Subject: MHI's Responses to US-APWR DCD RAI No.199-2073

Reference: 1) "Request for Additional Information No. 199-2073 Revision 1, SRP Section: 10.02.03 – Turbine Rotor Integrity, Application section Tier 2 FSAR Section 10.2.3," dated February 9, 2009.

Responses to Request for Additional Information
No. 199-2073 Revision 1

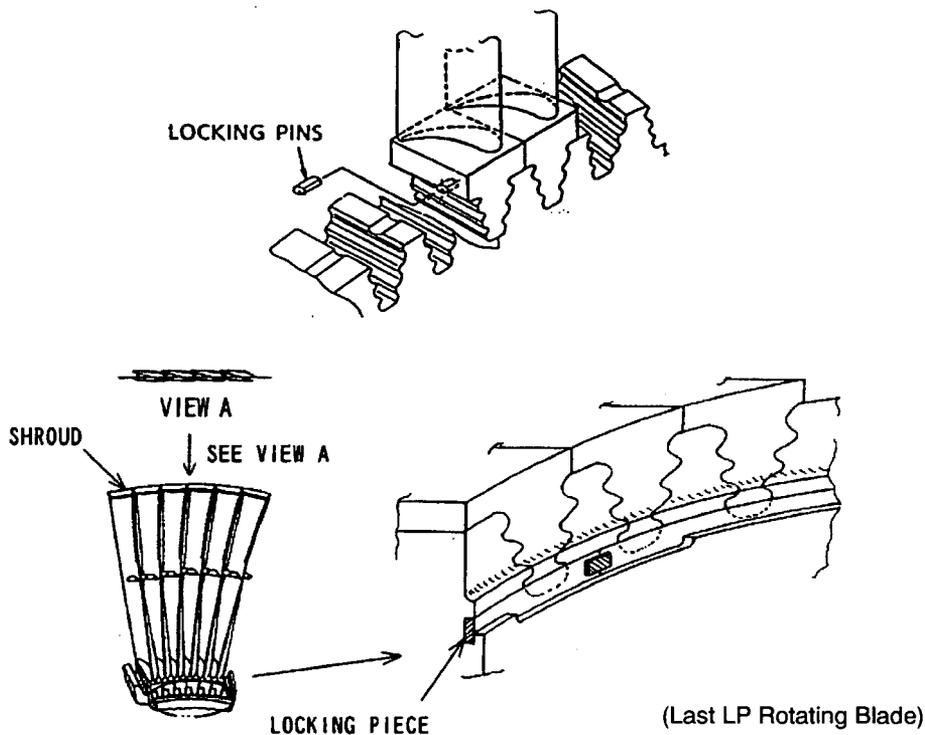
Provide a sketch of the christmas tree side entry type root attachment referenced in US APWR DCD, Tier 2, FSAR Section 10.2.3.4 for connecting the turbine blades to the rotor. Discuss how ultrasonic inspection performed during inservice inspection in accordance with US APWR DCD, Tier 2, FSAR Section 10.2.3.5 will be performed and whether 100% coverage of the area can be achieved for the christmas tree side entry type root attachment.

The sketch of christmas tree side entry type root is as follows.

In regard to ultrasonic inspection during inservice inspection for the christmas tree side entry root attachment, we made some mistake and need to revise DCD Subsection 10.2.3.5, the first bullet, the first item. "Magnetic particle inspection" on both inlet and outlet side will be conducted for every rows instead of "Ultrasonic inspection". In case of side entry structure as you see in the previous sketches, end-surface of rotor grooves are directly observed and visual and magnetic particle inspection are good enough to verify the existence of cracks.

- Each rotor, stationary and the rotating blade path component is inspected visually and by magnetic particle testing on its accessible surfaces. Magnetic Particle Ultrasonic inspection of the side entry blade grooves is conducted. These inspections are conducted at intervals equal or less than 10 years for both high-pressure and low-pressure turbines.

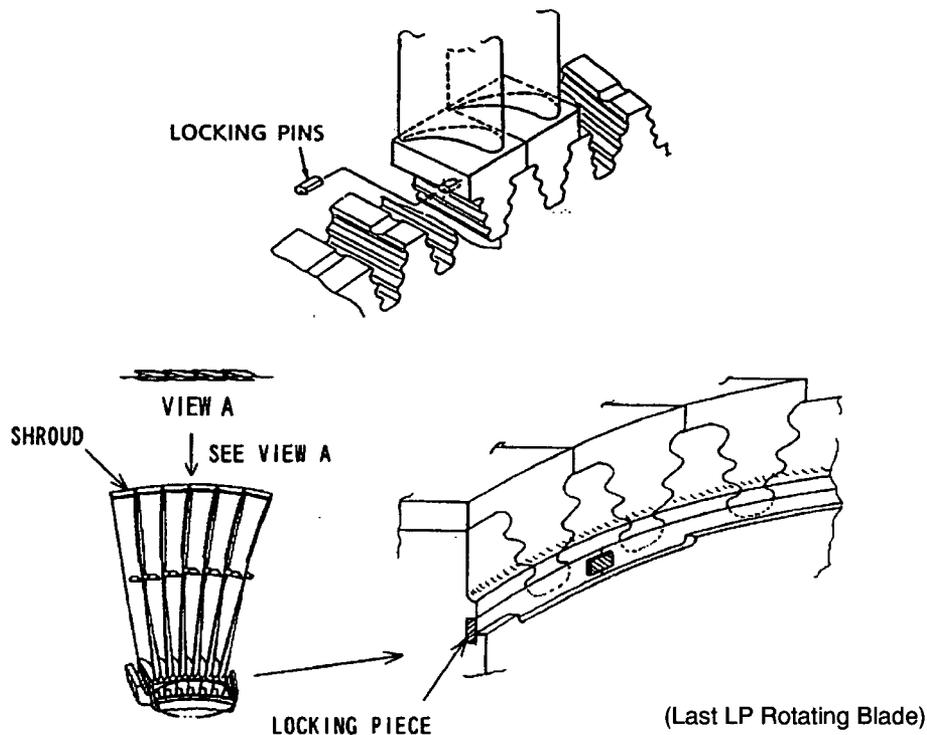
Provide a sketch of the christmas tree side entry type root attachment referenced in US APWR DCD, Tier 2, FSAR Section 10.2.3.4 for connecting the turbine blades to the rotor. Discuss how ultrasonic inspection performed during inservice inspection in accordance with US APWR DCD, Tier 2, FSAR Section 10.2.3.5 will be performed and whether 100% coverage of the area can be achieved for the christmas tree side entry type root attachment.

The sketch of christmas tree side entry type root is as follows.

In regard to ultrasonic inspection during inservice inspection for the christmas tree side entry root attachment, we made some mistake and need to revise DCD Subsection 10.2.3.5, the first bullet, the first item. "Magnetic particle inspection" on both inlet and outlet side will be conducted for every rows instead of "Ultrasonic inspection". In case of side entry structure as you see in the previous sketches, end-surface of rotor grooves are directly observed and visual and magnetic particle inspection are good enough to verify the existence of cracks.

- Each rotor, stationary and the rotating blade path component is inspected visually and by magnetic particle testing on its accessible surfaces. Magnetic Particle Ultrasonic inspection of the side entry blade grooves is conducted. These inspections are conducted at intervals equal or less than 10 years for both high-pressure and low-pressure turbines.
